Dear Editor,

Review #1

Summary: the authors offer an evaluation of FEWSNET S2S terrestrial water storage forecasts for Africa. The manuscript focuses on differences between the two land surface models included in the FEWSNET forecast ensemble--CLSM and Noah-MP--and offers commentary on the performance of each. Overall, they conclude that CLSM offers advantages when simulating and forecasting TWS. Results also show how various NMME meteorological S2S forecasts compare, but these results are not emphasized in the discussion. The primary source of evaluation data in the main text is GRACE, while information on precipitation forecasts is contained in supplementary material and is addressed only briefly in the text.

Fig.9 TWS percentile maps derived from Noah-MP and CLSM mean TWS forecasts (top two rows) of all NMME models, initialized in December 2015, and corresponding maps for GRACE/FO data (bottom row).

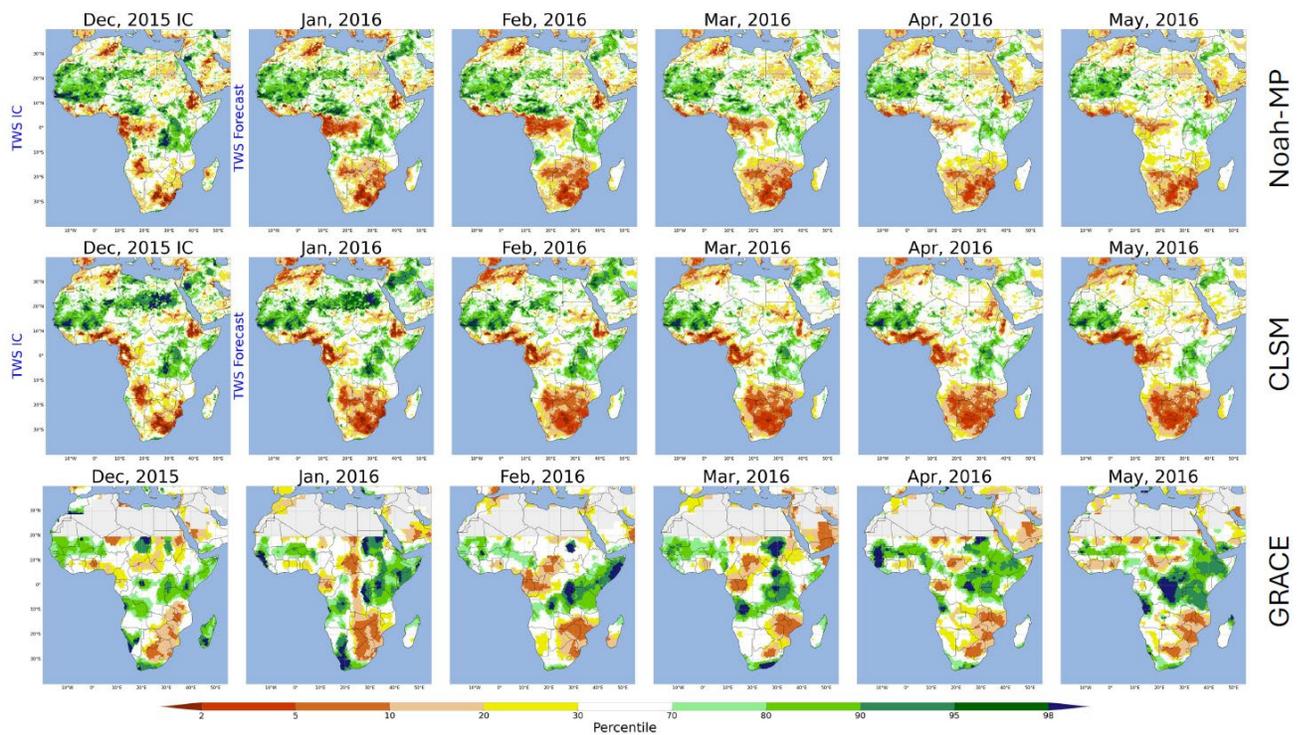
Section 3.4: Why aren't any GRACE comparisons offered in this section? It seems odd to show the forecast without any evaluation.

- L 358ff: would it make sense to involve percentiles from GRACE into the extreme event discussion?

- Fig. 8: Why do you show and discuss percentiles only for CLSM and not for NOAH?

Fig 8 . Can the authors make it clear that top left figure is the IC and everything else is forecasts? At first I thought top row was initialization, while the bottom was the forecasts.

Noah-MP and GRACE based percentile maps have been added in Fig.9 (previously Fig.8, see below image) and corresponding discussions have been included in this section.

Yes. GRACE based percentiles have been added. Please see our response to Review#1.

Noah-MP forecast percentiles have been added. Please see our response to Review#1.

The layout of this figure has been improved, and percentile maps of Noah-MP forecasts and GRACE data have been added. IC and forecast are now clearly labeled in the top two rows. Please see our response to Review#1 on update of this figure.

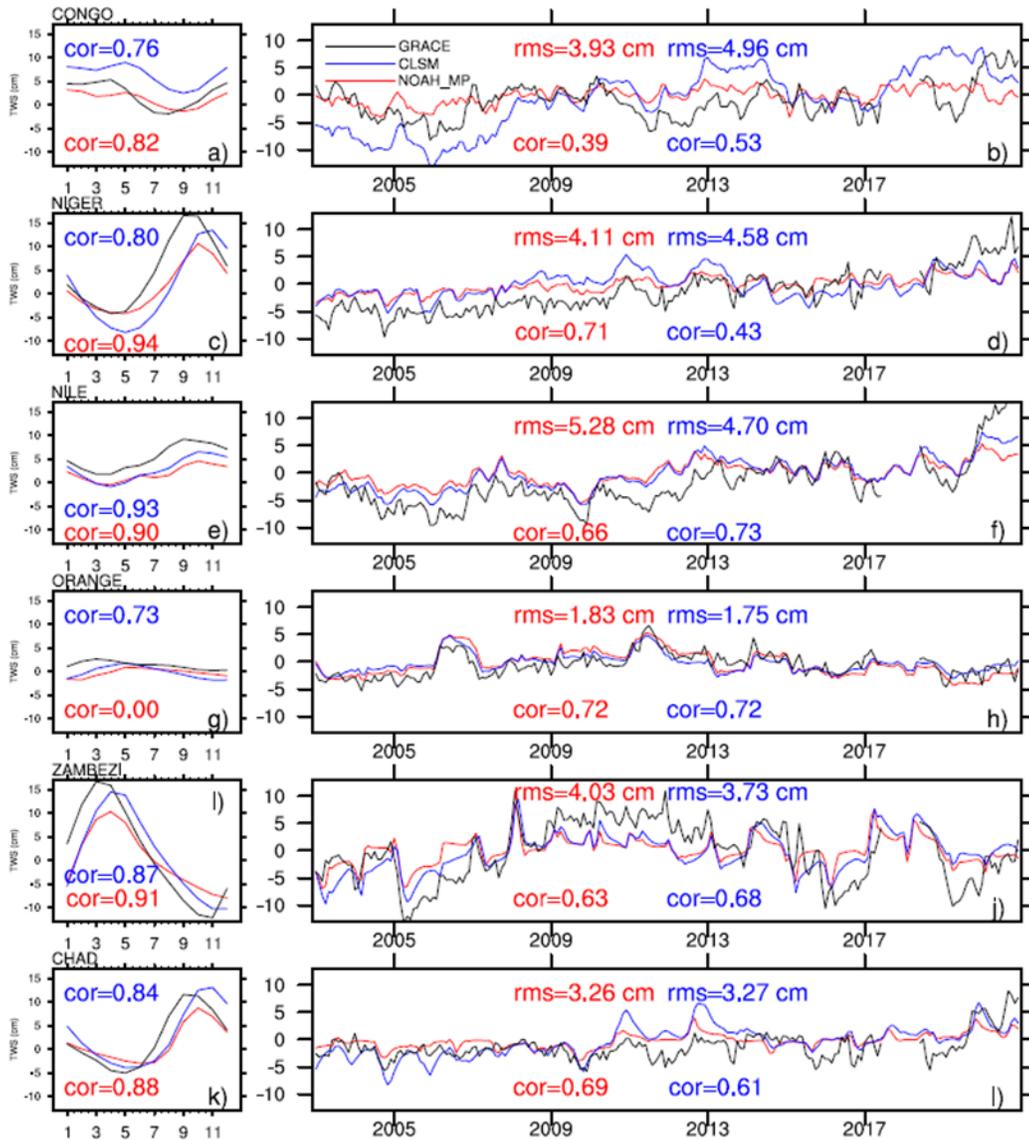
- The evaluations in Section 3.1 are based on time series averaged over the entire African continent. In my view, such continental-scale averages offer limited interpretive value due to the large diversity of climate zones and hydrological regimes. The authors also appear to have difficulties interpreting the signal they observe. It would be more informative to present time series for a selection of representative regions.

- L 203: Are you sure that it makes sense to average over such a huge study area? Wouldn't it be more appropriate to look at regions of interest? For instance, you are not able to interpret the interesting signals that you highlight in L 211, because you do not know from which part of your region they come.

In response to your comment, we added a new analysis (Fig.2 & Table 2) to show basin-scale TWS comparisons in section 3.1.

Multiyear variability is now discussed with respect to these basin averaged TWS time series: “To further evaluate the performance of reanalysis TWS, we analyze temporal variability of basin-average TWS time series for the six largest river basins in Africa (see Supplementary Fig.S1a for basin delineations). Seasonal TWS for both models show high correlations (generally >0.7) with GRACE/FO data in most basins, indicating that the timing of the seasonal cycle is well captured by the model (Fig.2, left column). Noah-MP often exhibits slightly higher seasonal correlations with GRACE/FO than CLSM (e.g., Congo, Niger, Nile, and Chad); however, its performance degrades substantially in

Orange, where the correlation is near zero (Fig.2g). This low correlation is attributed to the misalignment in the timing of annual minimum TWS, with Noah-MP reaching its seasonal low in February, whereas GRACE/FO observations (and CLSM) reach their seasonal low in November.

In contrast, the non-seasonal component of reanalysis TWS exhibits notably lower correlations with GRACE/FO (Fig.2, right column), reflecting greater challenges in simulating interannual TWS variability. CLSM generally achieves higher correlations than Noah-MP in the central and northcentral basins (Congo, Nile and Zambezi), whereas Noah-MP performs better in the northwestern basins (Niger and Chad). RMSEs are lower for each model in three of the six basins. Consistent with the domain averaged analysis (Fig.1), CLSM simulates larger seasonal variability and stronger interannual variability than Noah-MP, both of which are in closer agreement with GRACE/FO data (Table 2).

Fig.4 Correlation between non-seasonal reanalysis TWS and ensemble mean TWS forecasts of all NMME models at three lead times, and GRACE TWS observations for Noah-MP (top row) and CLSM (bottom row). Domain average correlations are shown in inset text.

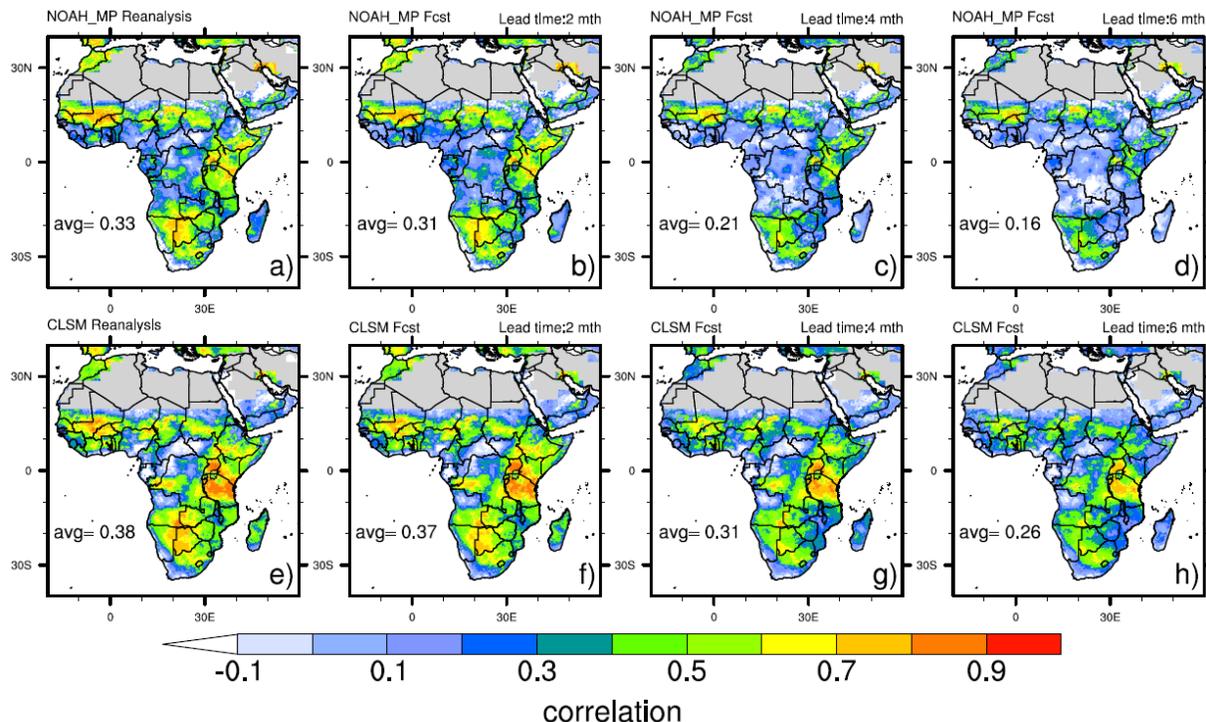
Fig 4. Why is the correlation so small already at 1-month lag time? How significant are these statistics?

Thanks for the question. As shown in the spatial correlation maps, there are regions of high correlations (see below). However, low and even negative correlations in certain areas (due to the opposite trends in simulated and GRACE observed TWS) suppressed domain-average correlations. We have updated the correlation and other maps using grey to mask out groundwater depletion regions and a triangle is used for the low end of the label bar (see below) to highlight that any values lower than -0.1 are shown in white.

The manuscript has also been updated to say, *“In CAR and South Sudan, TWS hindcasts from both models show near and below zero correlations with GRACE/FO data, due to the opposite trends between reanalysis TWS and GRACE/FO data in that region (Supplementary Fig.S2)”*.

We didn't do significance test as the purpose was to compare the correlation between the two models. Significance test also requires temporal independence of the data, which is not the case for TWS.

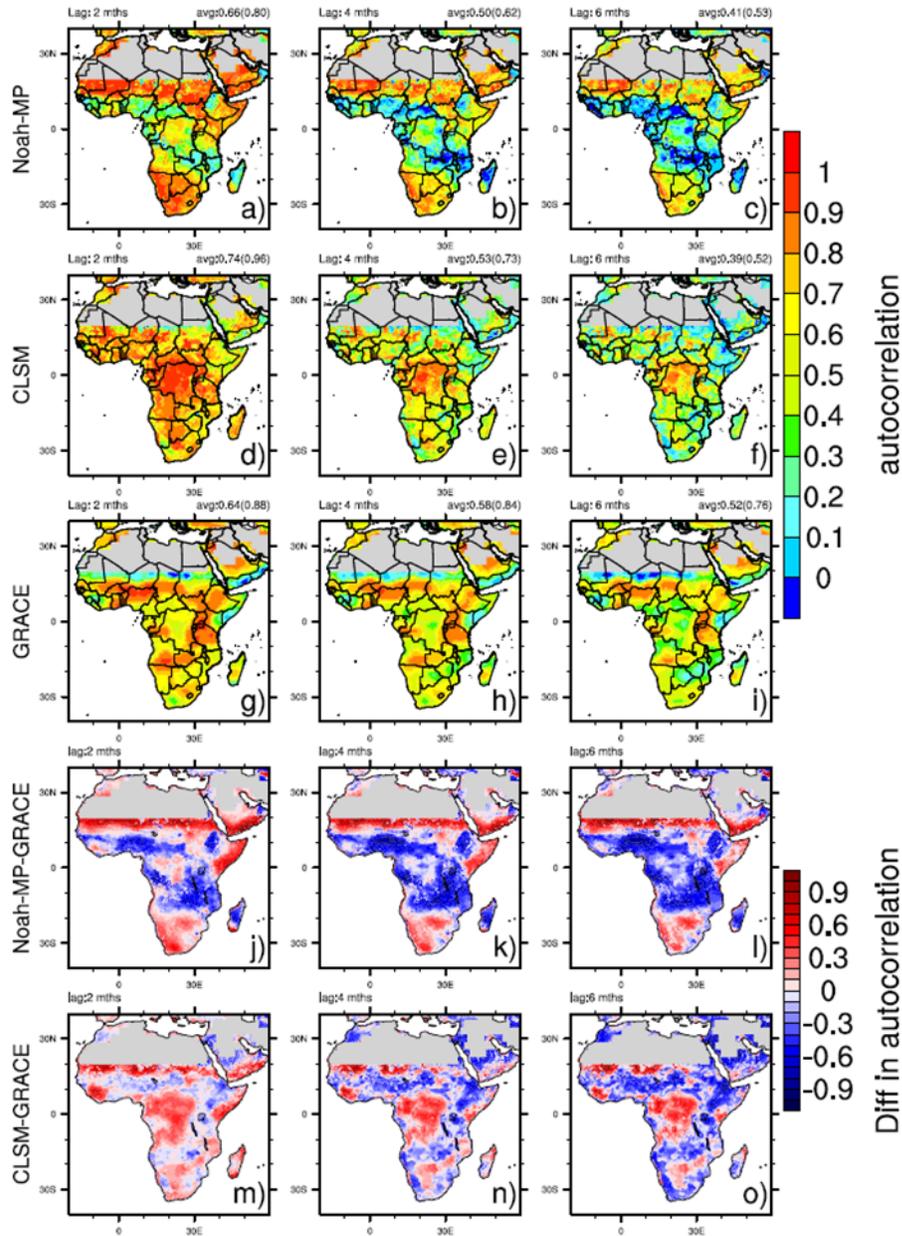
Fig 6 > wouldn't be useful to also show difference maps of the first two rows wrt GRACE (bottom)?

Thanks for the suggestion. We now show differences in persistence (see below image) and added the following text to the manuscript, *”Differences between simulated and GRACE/FO TWS persistence exhibit spatial patterns similar to those of mean annual precipitation, reflecting the strong influence of precipitation and associated uncertainty on persistence (Fig.7, bottom two rows). However, the two models often exhibit contrasting performances. Compared to GRACE/FO TWS, Noah-MP underestimates persistence in central Africa and overestimates it elsewhere. In contrast, CLSM overestimates persistence in central Africa while underestimating it in other regions, a discrepancy that is more pronounced at the 2- and 4-month lags. In wetter central Africa, strong interannual variability in CLSM TWS helps retain past wetness conditions and contributes to its enhanced persistence. On the other hand, the underestimation of persistence by CLSM in drier regions may be linked to the model's tendency to overestimate ET, which acts as continuous disruption to soil moisture states, thus leading to low persistence. For both models, discrepancies between reanalysis and GRACE/FO increase with increasing lags (Fig.7, bottom two rows), reflecting cumulated differences in their abilities to retain past states”*.
